Kingston Parish Council – Objection to K/3/26/PD

Location: Potato Barn, Kingston Lane BN16 1RS

Re: Prior approval under Schedule 2, Part 3, Class Q for the conversion of existing barn into 3 No dwellings.

**Proposed Site Plan
(Current application K/3/26/PD)**

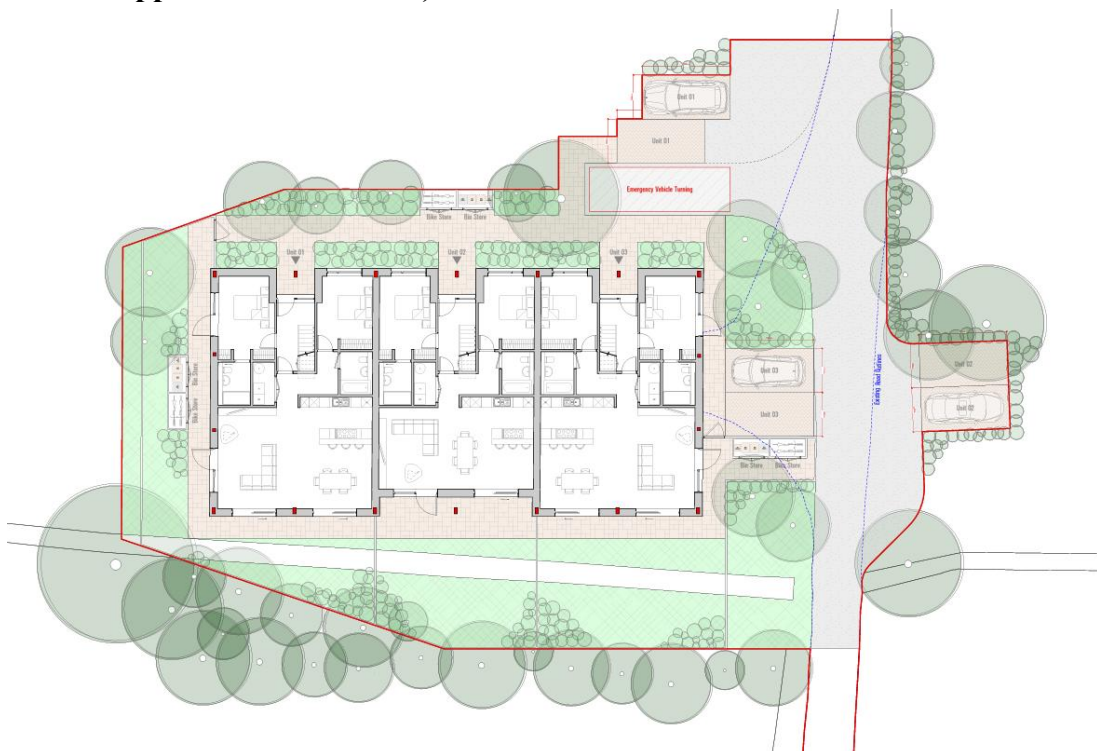
11. The area of the application has been significantly extended outside the curtilage of the barn. The application now proposes a turning circle and car parking next to the barn and across the track as well. Plus, it includes gardens and hard standing to the West, South and North with significant clearance of vegetation to the south. Arguably, this is not covered by Class Q, even though the redline has been drawn around these features. Note: the redline for this application K/3/26/PD covers a significantly larger area than the curtilage shown for the previous application.

The incursion of car parking, gardens and hard standing into the open countryside has an urbanising impact on this rural area and should be refused as an unacceptable transport and highway impact of the development and as causing an adverse visual impact.
